Work Order ID 134362

Item ID: D206-642-341 Accept ***N900040100*** Setup Start ***NS1***
 Revision ID: Stop ***NS2***
 Item Name: Replacement Skidtube (Fits LH or RH)
 Start Date: 6/29/15 Start Qty: 1.00 ***1*** Cust Item ID:
 Required Date: 7/07/15 Req'd Qty: 1.00 ***1*** Customer:
 Reference:

DRAWING NO. D2650	TITLE 206/407 SKIDTUBE ASSEMBLIES	REV. F	DART AEROSPACE LTD ENGINEERING ORDER		D.E.O. NO. D2650-F-1	SHEET NO. SHEET 1 OF 1	SCALE NTS
DRAWN <i>[Signature]</i>	CHECKED A.P.	MFG. APPR. <i>[Signature]</i>	APPROVED <i>[Signature]</i>		DE APPR. <i>[Signature]</i>		
DATE 12.10.12	DATE 12.10.22	DATE 12.10.22	DATE 12.10.22		DATE 12.10.22

CHANGE C'BORED WELDED CROSSBOLT SPACERS TO SWAGED SPACERS

DETAIL G
FOR Ø0.375 HOLES ONLY
FOR HOLES THAT ARE CURRENTLY C'BORED ONLY
NOT TO SCALE

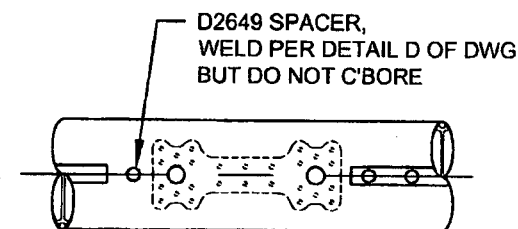
ADD DETAIL G BELOW, WHICH IS THE SAME SECTION VIEW AS DETAIL D OF DWG.
C'BORED HOLES ARE **NOW SWAGED** PER DETAIL G BELOW. FOR THE Ø0.375 HOLE THAT IS NOT C'BORED, WELD PER DETAIL D OF DWG (SEE AMENDED DETAIL B FOR REFERENCE).

AFTER DRILLING AND BENDING ASSEMBLY
PERFORM THE FOLLOWING FOR Ø0.375 HOLES THAT ARE
CURRENTLY C'BORED:

1. INSERT D4720-1 SPACER, 16 PL (-1) OR 17 PL (-3)
OR 19 PL (-5) OR 23 PL (-7)
2. SWAGE TO Ø0.313 X 0.75 DP PER QSI 002
3. TRIM / GRIND FLUSH PER QSI 002
